PREVOST

WARRANTY BULLETIN

Wb99-05

DATE : June 1999	SECTION : 06, Electricity
EXPIRATION :	June 2000
SUBJECT : ELECTRICAL RESISTORS ADDITION ON CONDENSER RELAYS

Figure 3: Main power compartment. Final aspect of connections for W2219 to X2809 vehicles.

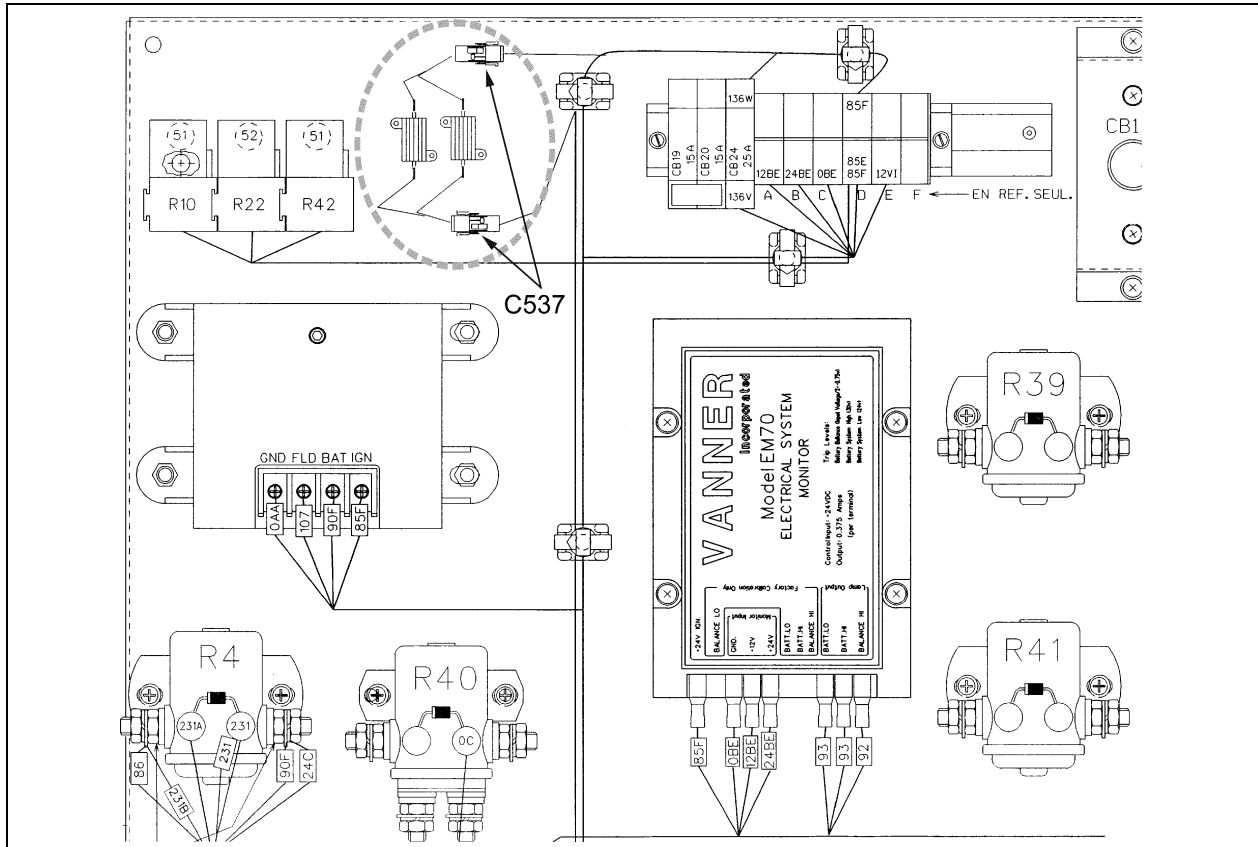
1. Open the main power compartment (figure 1).
2. Notice a free space close to the C537 connectors. This space will be used to connect two #064907 electrical resistors.
3. Using an "A" drill size bit, drill two 3/32 in (2-3 mm) diameter holes in order to fix the electrical resistors as shown on figure 3.
4. Fix the electrical resistors to the electrical panel and connect them to the C537 connectors as presented on figure 3.

Figure 4: Typical location of condenser compartment.

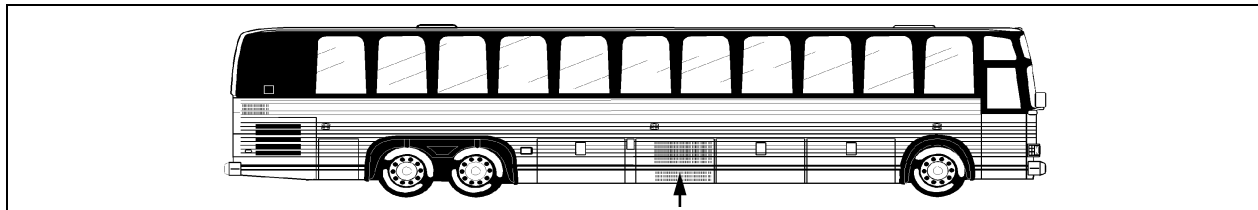
1. Open the condenser compartment (figure 4).

Figure 7: Final aspect of the A/C junction box. Only new connections are shown.

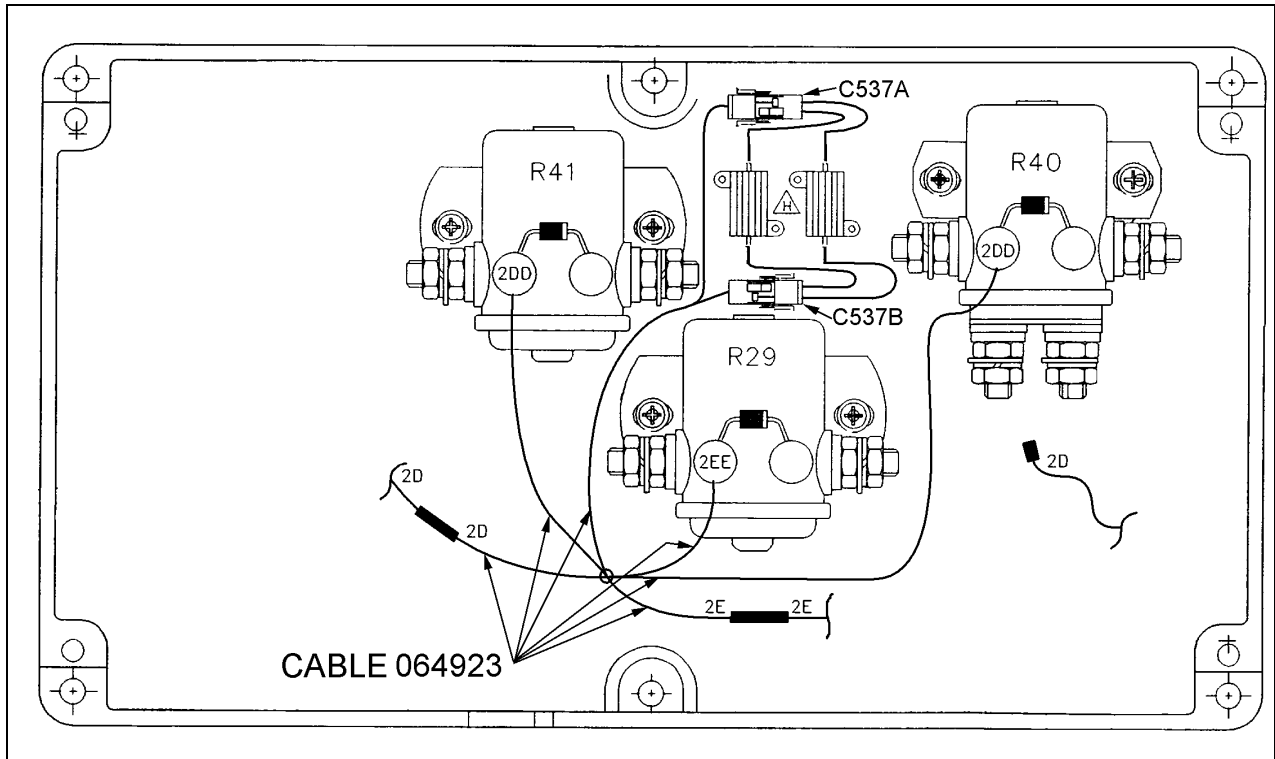
6. Plug wires 2DD pertaining to #064923 cable into R40 and R41 relays, as shown on figure 7.
7. Plug wire 2EE pertaining to #064923 cable into R29 relay, as shown on figure 7.
8. Fasten both electrical resistors above R29 relay using #500798 screws (figure 7). Plug the electrical resistors to C537 A and B connectors.
9. Replace the A/C junction box lid and close the condenser compartment.
